PLANNING BOARD AGENDA
MARCH 14, 2018 – 7:00 P.M.

Re: *Hudson Valley Federal Credit Union – Mahopac Branch*
Response to Planning Board Comments
Job # 10512.26

Comments from the Office of the Town Engineer, in a memorandum dated January 8, 2018

Hudson Valley Federal Credit Union - Mahopac - Monument Sign - Footing / Structural Support Details

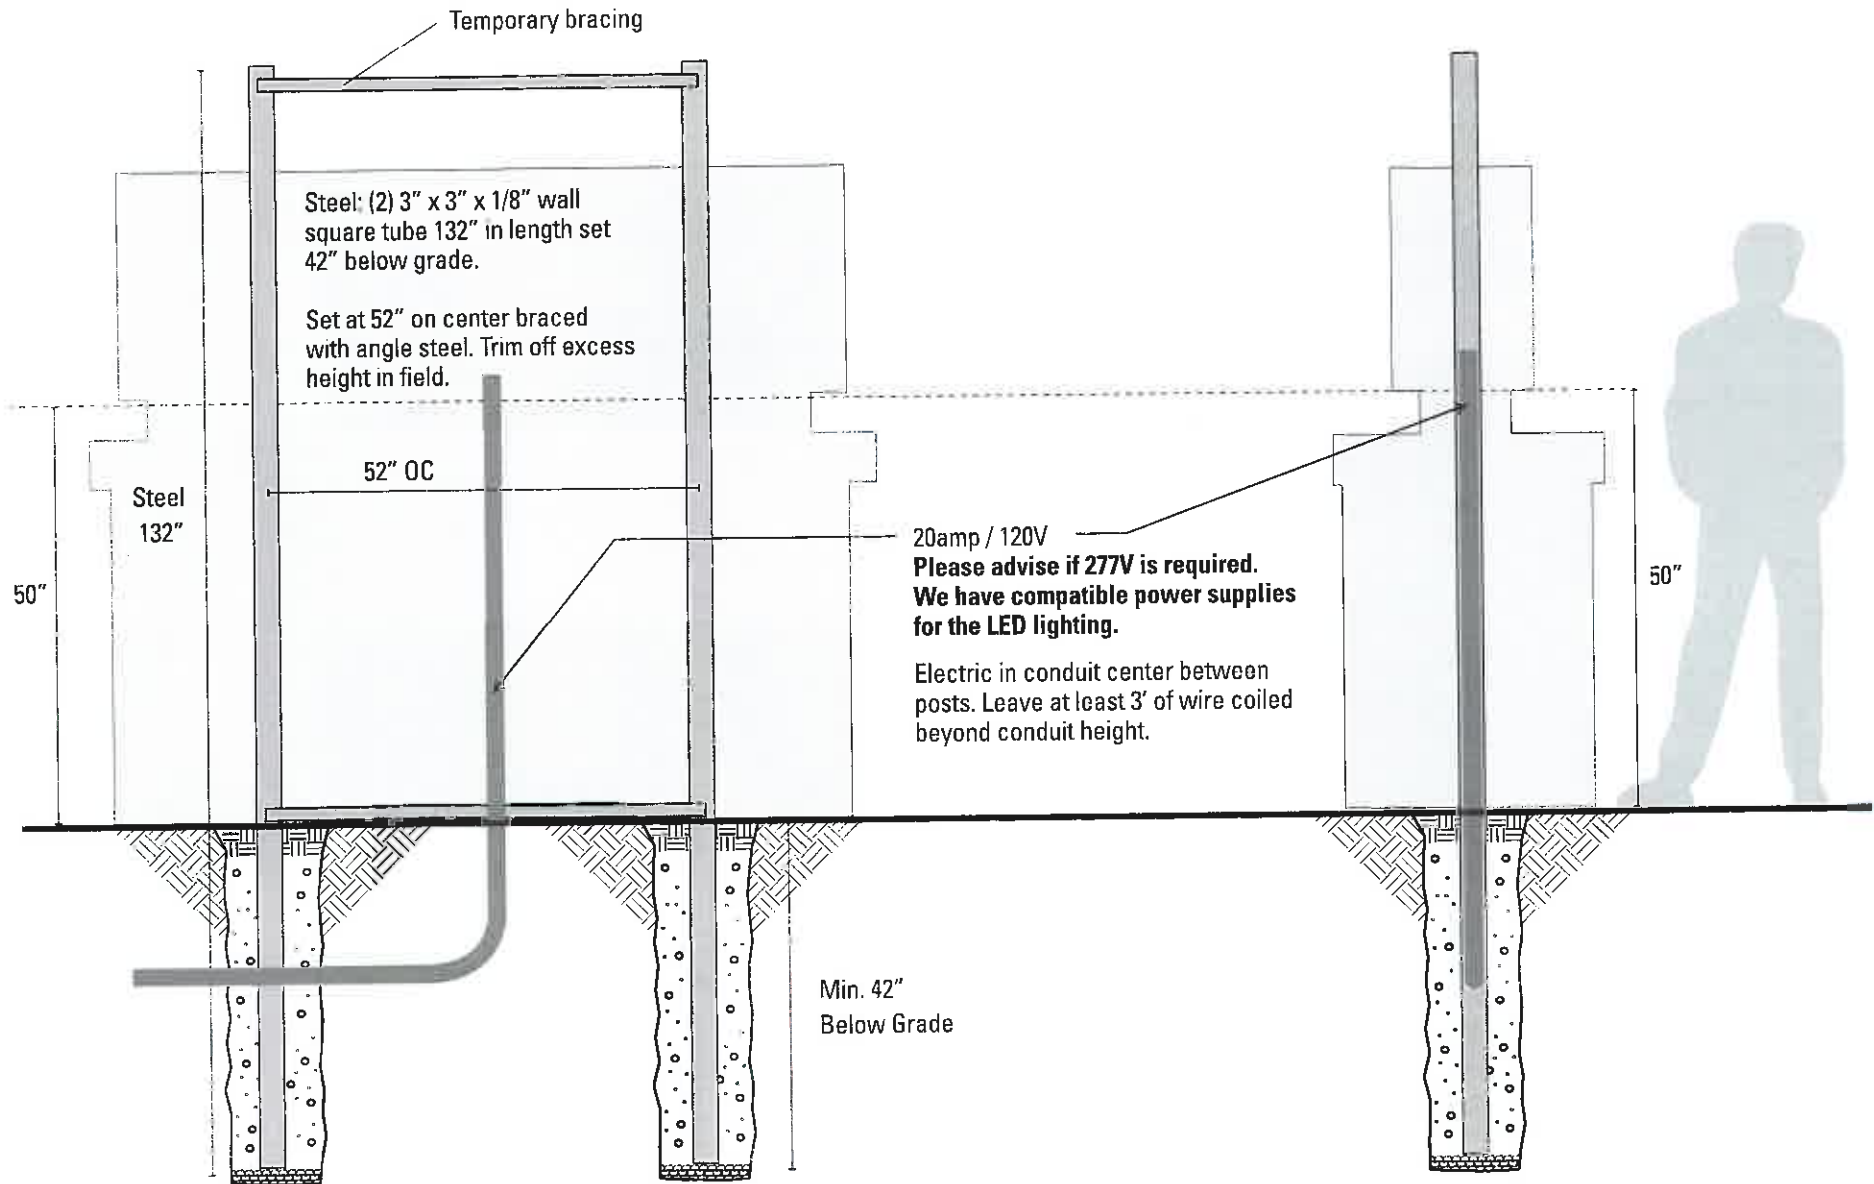
6. *Comment – The applicant should provide wind load calculations for the canopy.*

Response: Please see the attached letter from Consulting Engineer, John Stinemire, to Jay Diesing at Mauri Architects PC regarding the wind load calculations for the canopy.

1. PLANTING AND GUYING DETAILS FOR TREES SMALLER THAN 3" CALIPER, BALLED AND BURLAPPED SCALE: NOT TO SCALE

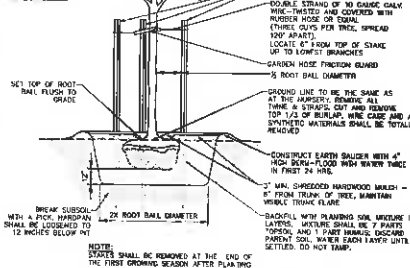
13. *Comment – All plantings shall be installed per Section 142 of the Town of Carmel Town Code.*

14. *Comment – A three (3)-year warrantee on all plants should be provided.*

Response: Planting details and notes have been revised

Response: A note indicating this has been added to the landscaping details.

1 CAR MOVEMENT
SCALE 1"=20'

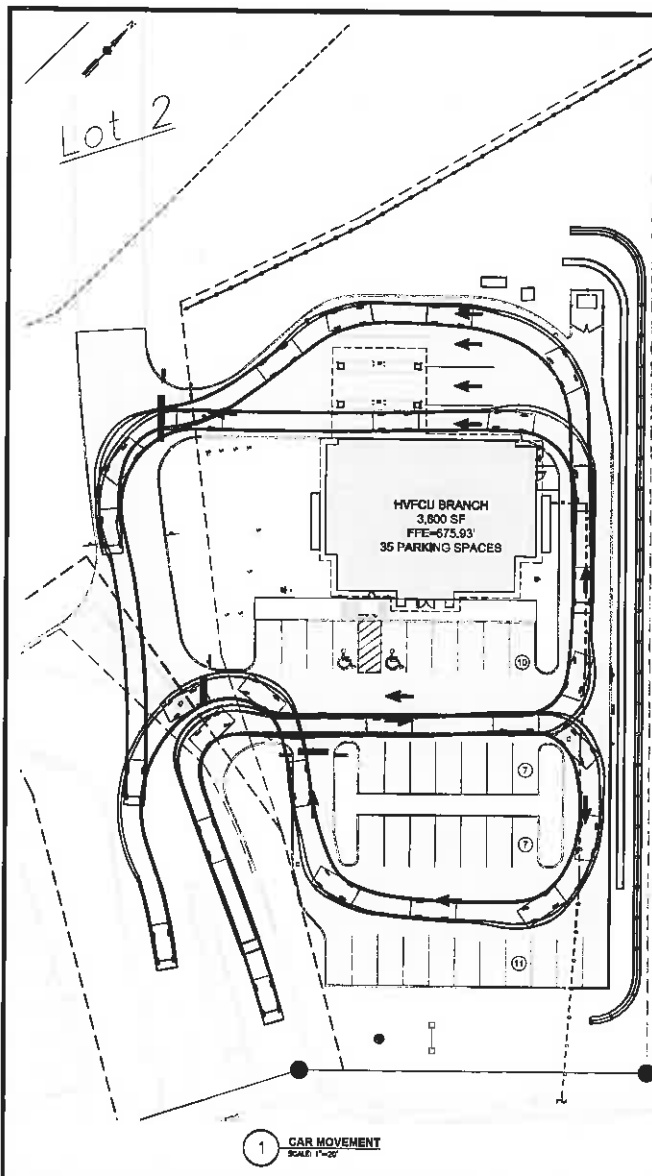
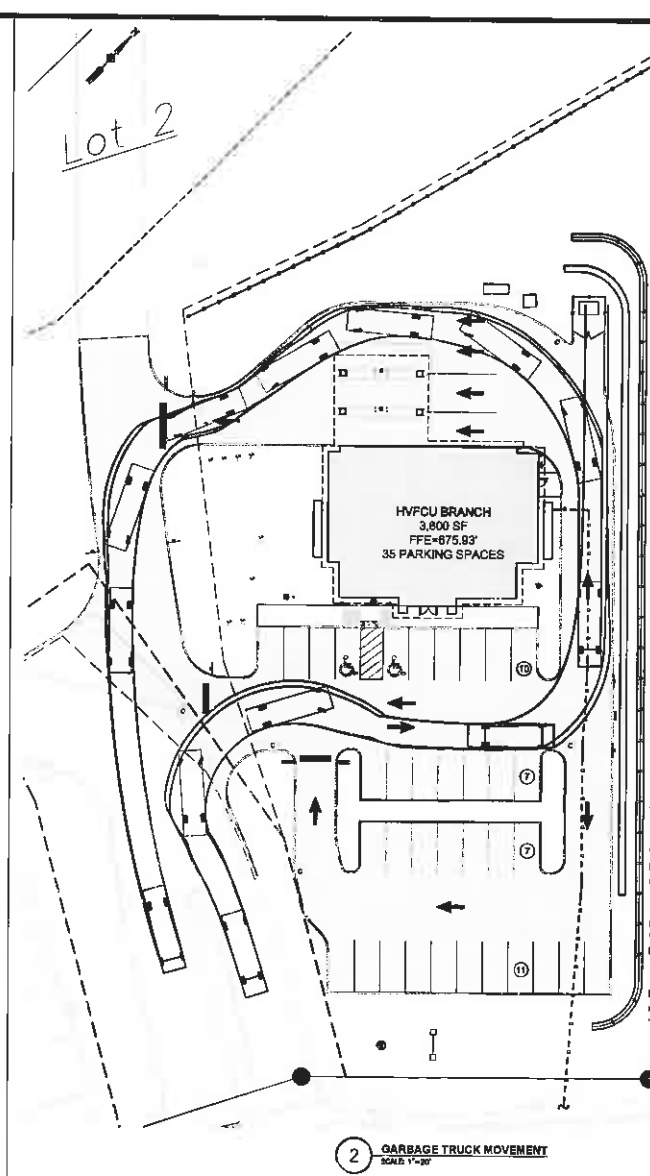
8. *Comment – Graphic representation of vehicle movements through the site should be provided to illustrate that sufficient space exists to maneuver all types of vehicles anticipated at the site.*

Response: Sheet C590 has been added to show vehicle movements through the site.
